MINING IMPACT SPECIALISTS LTD. <small>ENABLING CHANGE TO SERVE FUTURE GENERATIONS.</small>	 <small>EST. 1971 LIMITED environmental research associates</small>	2023 Mary River Project Site Visit #2		
		Key Photos from September 2023 Inspection		
Mining Impact Specialists Ltd.	LGL Limited	Date: 05 Dec 2023	Approved: LEB	Page: 17

RESPONSE TO QIA September 2023 General Site Inspection Findings and Recommendations

To:	Jim Patterson	Date:	February 6, 2024
c:	Baruck Wile, Rudolf Dietrich, Emmanuel Ocran, Abid Najey	Memo No.:	
From:	Charlie Harrison	File:	704-ENG.EARC03209-10
Subject:	Revised the Issued for Construction (IFC) Drawings for the KM105 Sedimentation Pond Grout Curtain

The Qikiqtani Inuit Association (QIA) contracted M.A. O' Kane Consultants Inc. (Okane) to complete the 2023 Environmental Audit (Audit) of the Mary River Project (Project), operated by Baffinland Iron Mines Corporation (Baffinland). This Audit was completed in accordance with Schedule D and E of the Commercial Lease No.: Q13C301¹ (Lease). The focus of the Audit was to verify the adequacy of environmental security provided by Baffinland pursuant to the Lease.

C:\Users\robin.chen\Documents\Hongwei\Charlie\01-24-24\DWG\DWGS for IFC\IARC03209-C012 C031-C035 C041 C043-C045-C046 Option W.dwg [C031] February 06, 2024 - 4:16:26 pm (BY: CHEN, ROBIN)

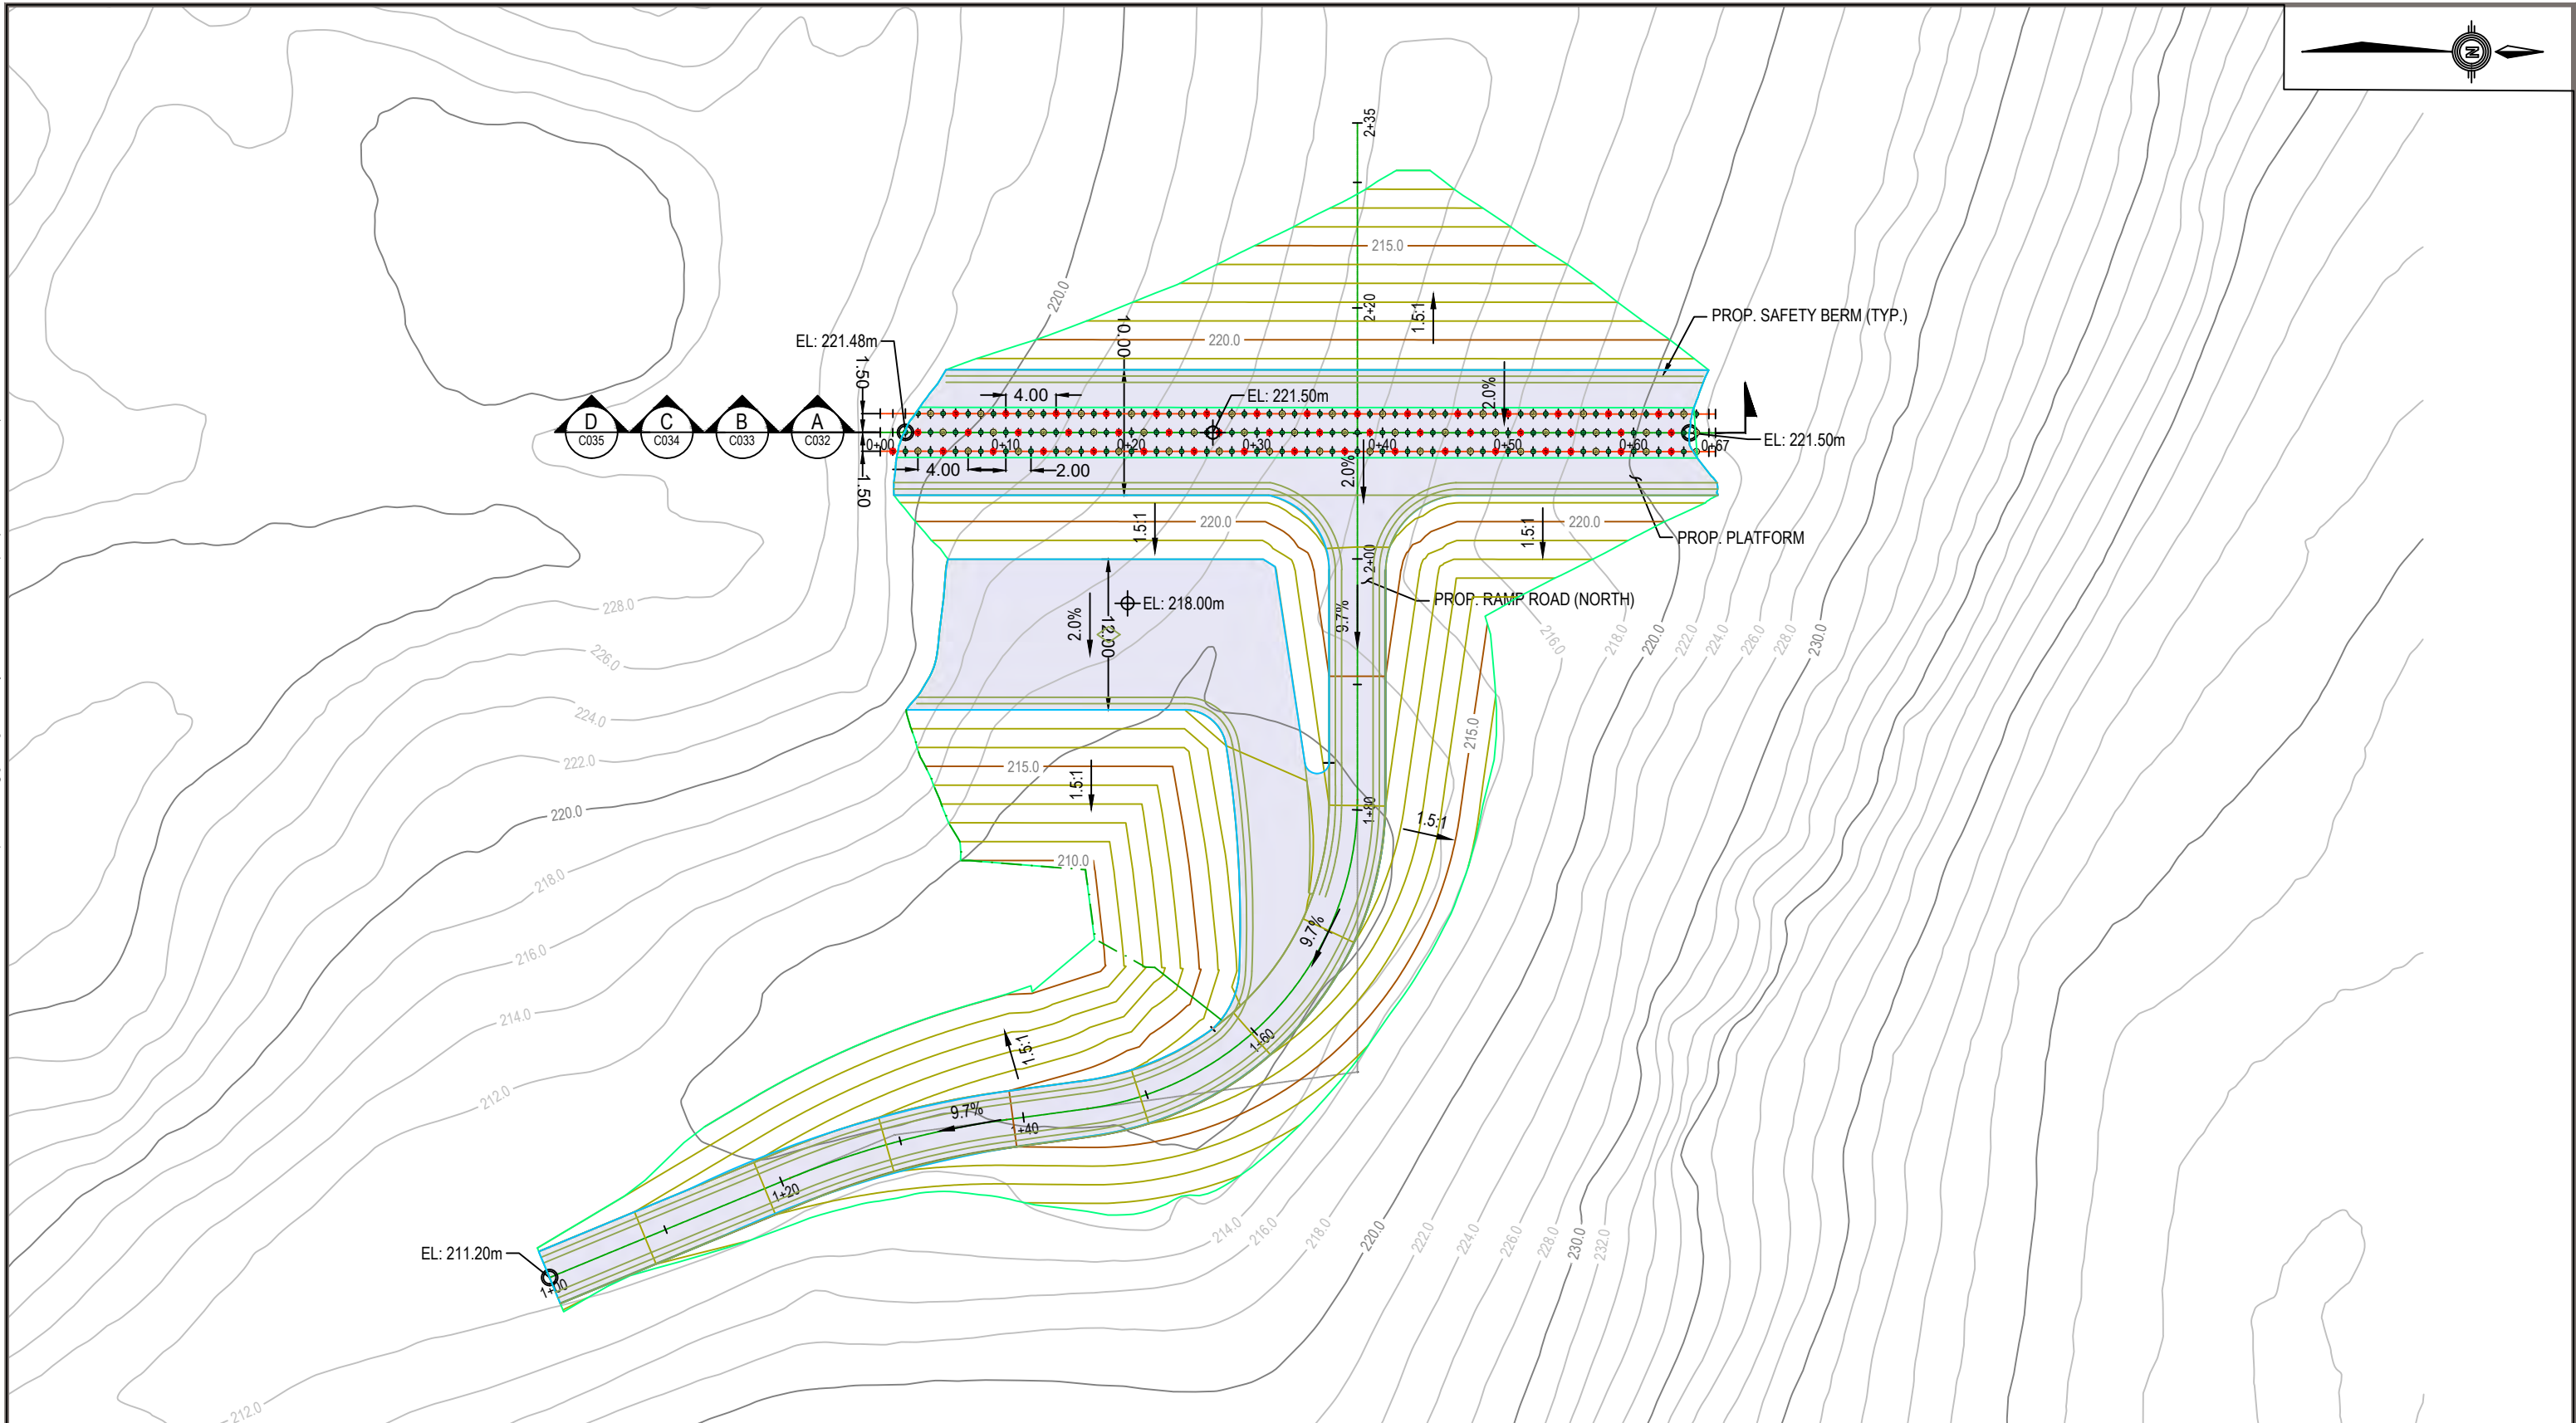
1. Revised alignment for the grout curtain: the grout curtain was shifted to the east by about 25 m to allow for the grout holes to be advanced through the existing geomembrane liner. This will accommodate a direct connection between the top of the grout curtain and the existing liner system for the pond.
2. Revised alignment of the temporary platform: the temporary platform was realigned to match the revised alignment of the grout curtain.
3. Temporary platform fill material: the central core material was changed to 19 mm minus crushed sand and gravel from 50 mm crushed sand and gravel to accommodate the change in drilling methodology, as recommended by Keller.
